May 17, 2019

SUBJECT: Coastside Design Review Continuance  
Isabella Road, El Granada  
APN 047-244-240; County File No. PLN 2017-00509

At its meeting of May 9, 2019, the San Mateo County Coastside Design Review Committee (CDRC) considered your design review application to allow construction of a new 2,662 sq. ft. two-story single-family residence (including a 477 sq. ft. attached two-car garage) on a 5,000 sq. ft. legal parcel (Recorded Lot Line Adjustment (LLA 81-14)). The project involves minor grading and no tree removal.

Floor and Roof Plan A2.1

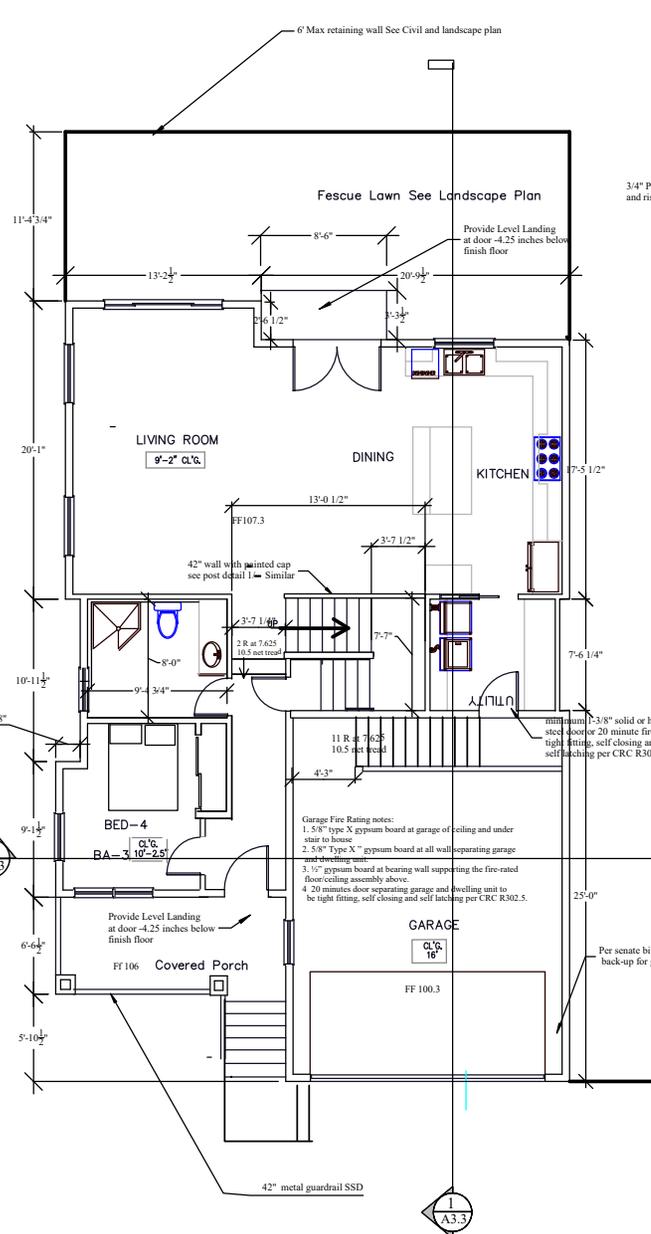
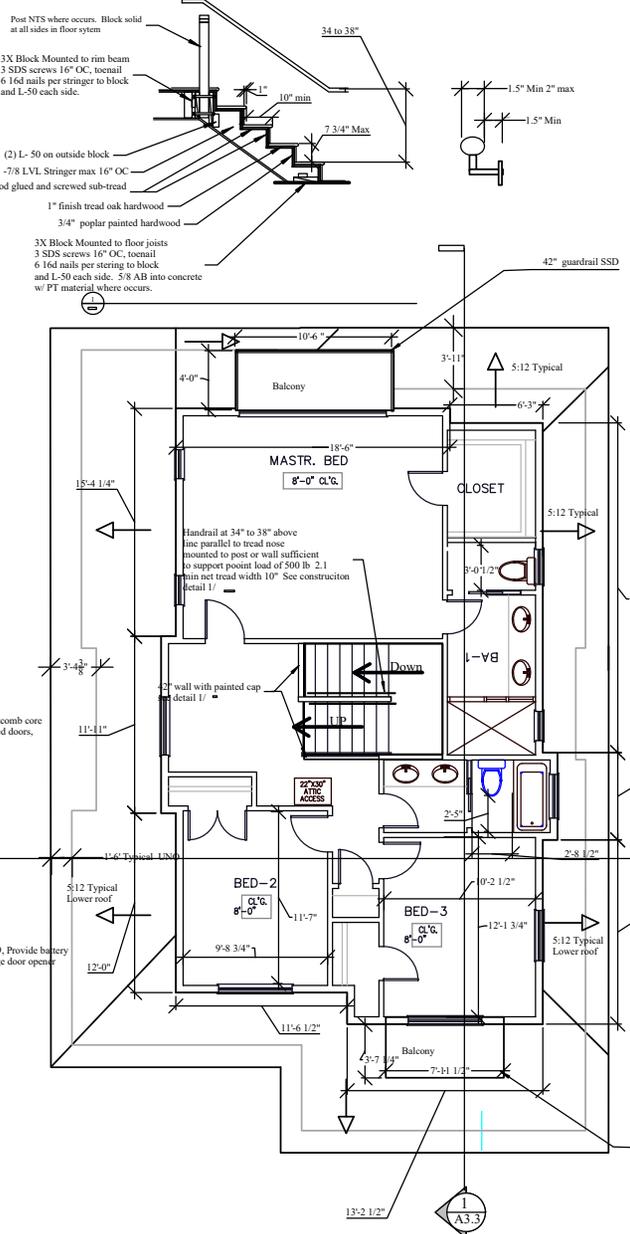
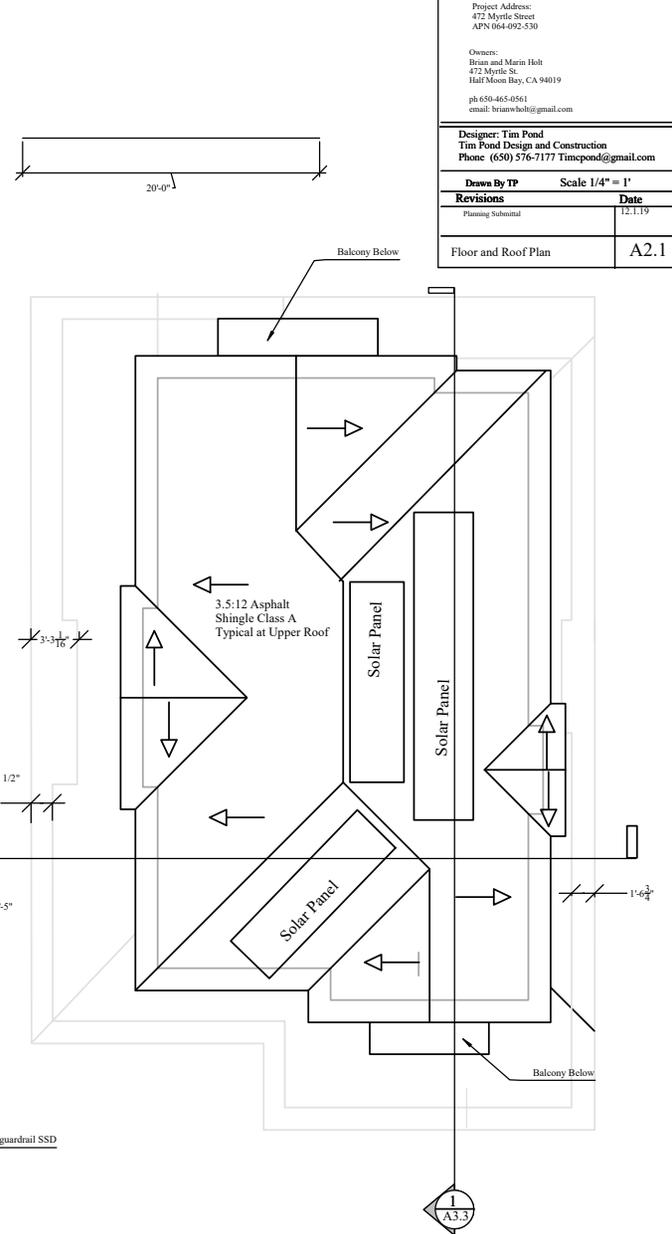
- c. Provide a roofing plan, including roof slope and roof tile specification.
4. Provide a physical sample of the roofing tiles. Dark brown muted color is presented. Avoid use of roof tiles of a bright color such as terracotta.

**1 East Elevation**  
 Note: Finish callouts are typical to all elevations

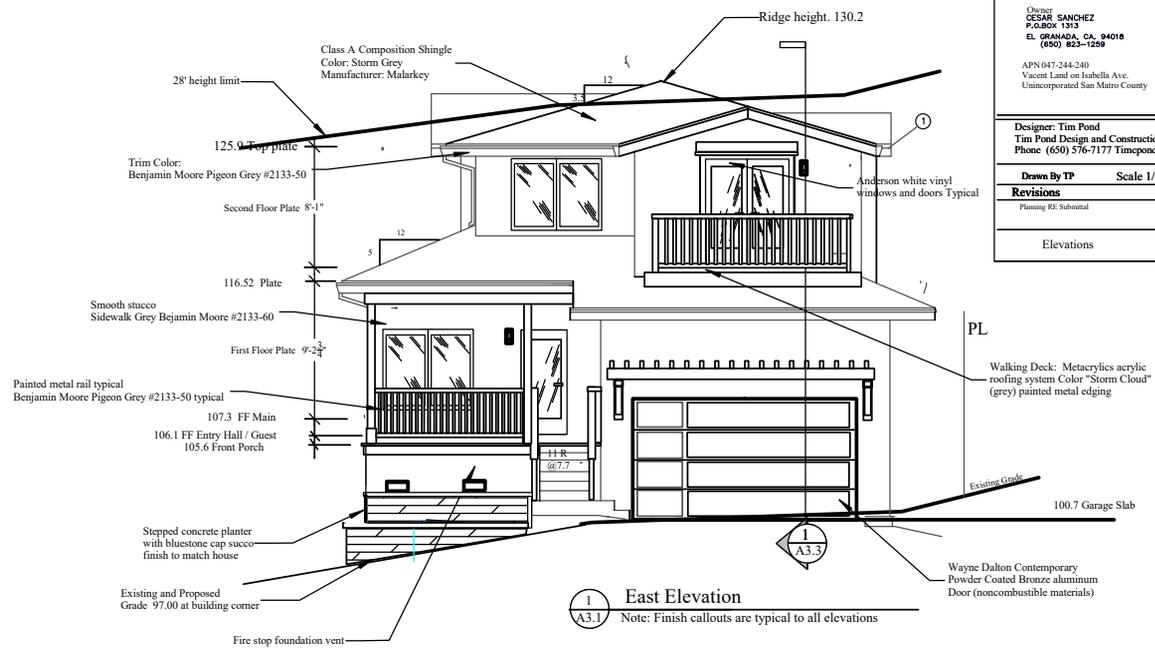
3. Revise the design drawings to reflect the following:
  - a. For the room over the garage on the Front elevation, extend the width of the columns and the depth of the arched facade out from the building wall to 2-3 inches.

- b. Revise plans to accurately show the Front elevation, especially the height of the garage in relation to the finished floor level, the transom space above the garage lights, and the level of the front porch and steps. Consider reducing eave height and remove transoms above garage door to achieve better proportions.
